## ORDINANCE NO. 15-1011

**AN ORDINANCE OF THE CITY OF OREGON CITY AMENDING TITLE 17: ZONING, CHAPTER 17.06.020: OF THE OFFICIAL ZONING MAP, OF THE OREGON CITY MUNICIPAL CODE, BY CHANGING THE PROPERTIES IDENTIFIED AS CLACKAMAS COUNTY MAP 3-2E-07B -02300, CLACKAMAS COUNTY MAP 3-2E-07BA-07000, AND CLACKAMAS COUNTY MAP 3-2E-07BA-06900 FROM R-10 SINGLE-FAMILY DWELLING DISTRICT TO R-8 SINGLE-FAMILY DWELLING DISTRICT AND APPROVING A 19-LOT SUBDIVISION AND A NATURAL RESOURCE OVERLAY DISTRICT VERIFICATION.**

- A. Staff Report for Planning file ZC 15-01, TP 15-02 and NR 15-04

**FILE NUMBERS:** ZC 15-01: Zone Change R-10 to R-8  
TP 15-02: 19-Lot Subdivision  
NR 15-04: Natural Resource Overlay District Verification

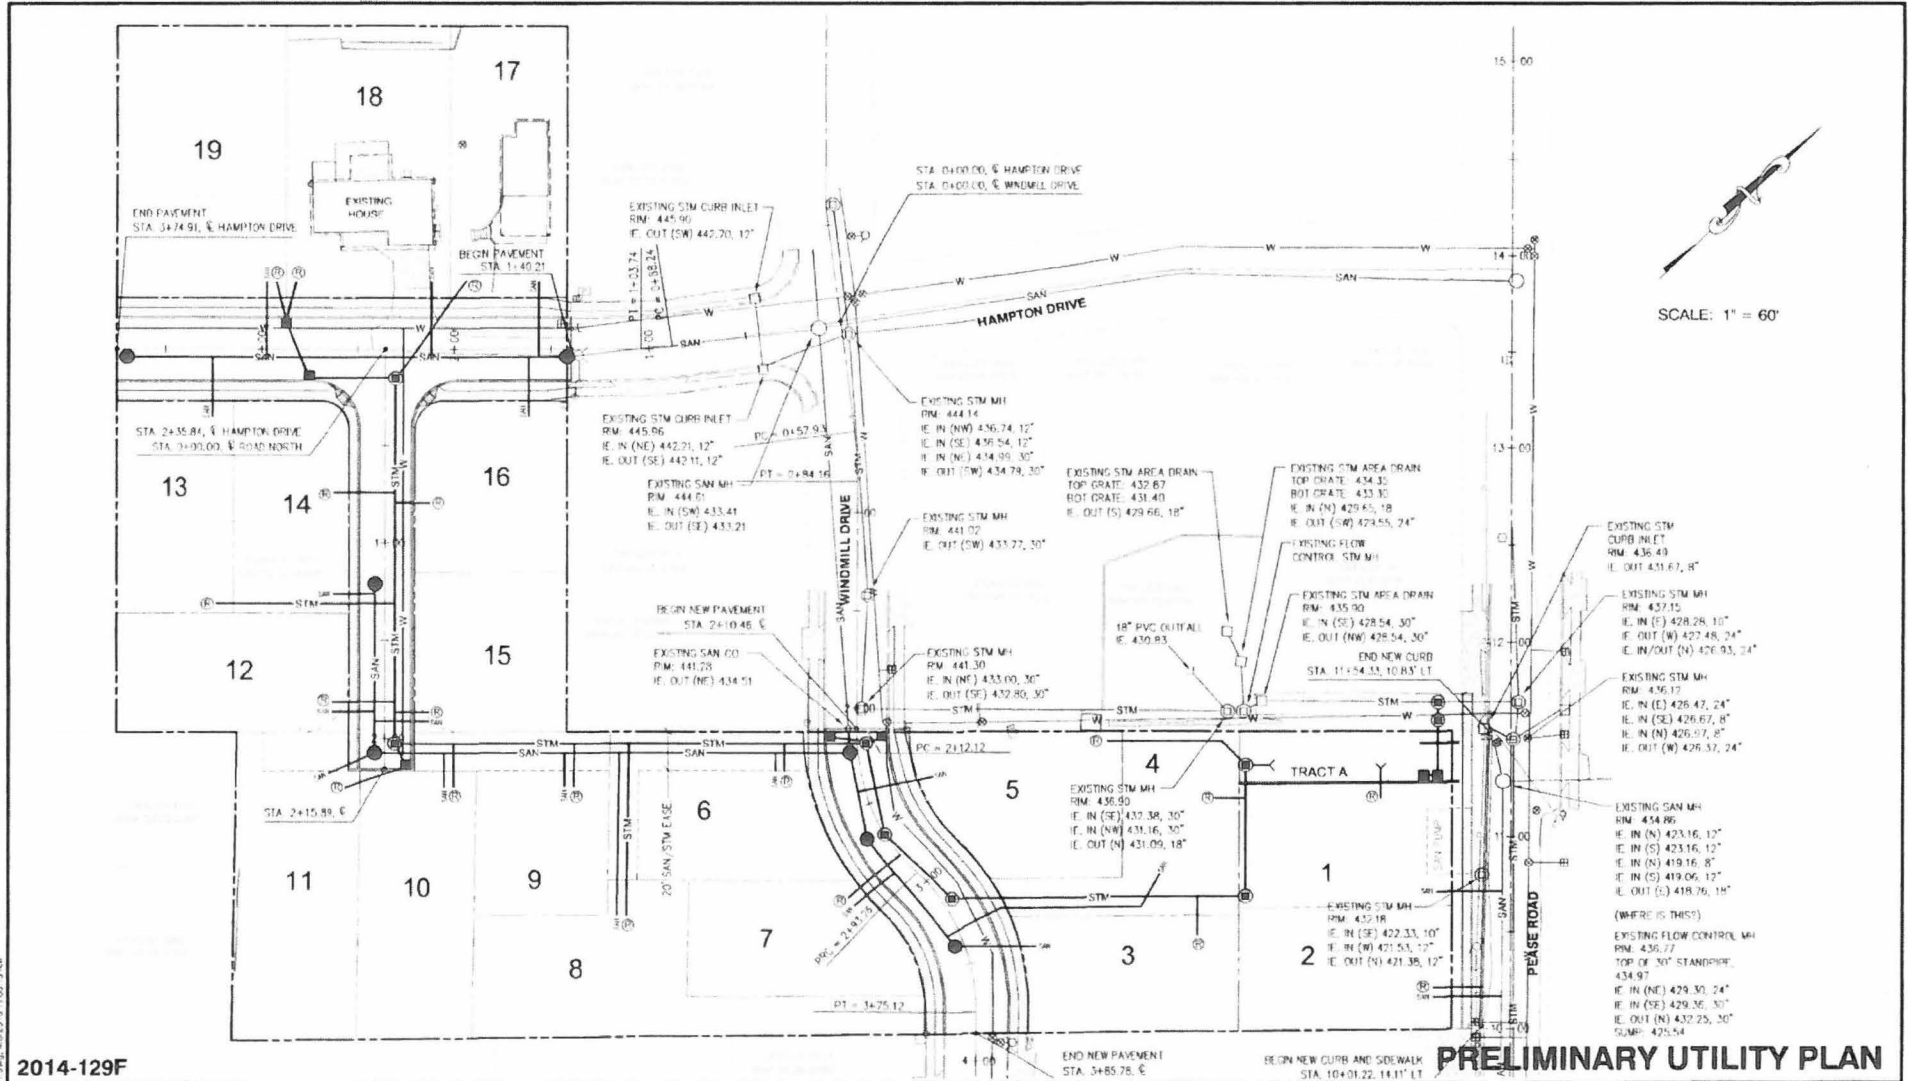
In the narrative, the applicant has indicated that the stormwater facility will be adjacent to and combined with the existing Hampton Estates subdivision pond, but that has not been reflected on the plans. The two ponds shall be combined as indicated; the construction plans will need to show an adjusted pond design such that the two ponds are made into one facility.

A cursory review of the adjacent segments of Windmill Drive suggests that the proposed segment across the subject property may need to be constructed with a vertical curve (high point). This will revise the proposed storm system in this street. The two proposed catch basins at the NE terminus may not be necessary.

The catch basin to catch basin configuration proposed at Hampton Drive and Boulder Run Court is not standard and will need to be revised on the construction plan unless there is adequate justification to eliminate a standard manhole connection.

Configuration of the private storm lines for Lots 1, 3, 4 and 5 appears to be unnecessarily complex and problematic in terms of maintenance access. Alternative arrangements will need to be addressed with construction plan submittal. Several other private lines are proposed to be connected to public manholes or catch basins, and are placed at angles that are not ideal for maintenance purposes. The services should be discharged to the curb line through a weephole where possible or connected in to the public storm main.

The plan shows an existing storm manhole in Pease Road at approximately Station 10+75. City records indicate this may be an abandoned sanitary manhole. This will need to be clarified on the construction plans, and will need to be removed if required for the street improvements.

16. Construction plans shall show an adjusted stormwater facility design incorporating the proposed pond with the adjacent Hampton Estates pond or as otherwise approved by city engineer. (DS)

22. The catch basin to catch basin configuration proposed at Hampton Drive and Boulder Run Court is not standard and will need to be revised on the construction plan unless there is adequate justification to eliminate a standard manhole connection. (DS)
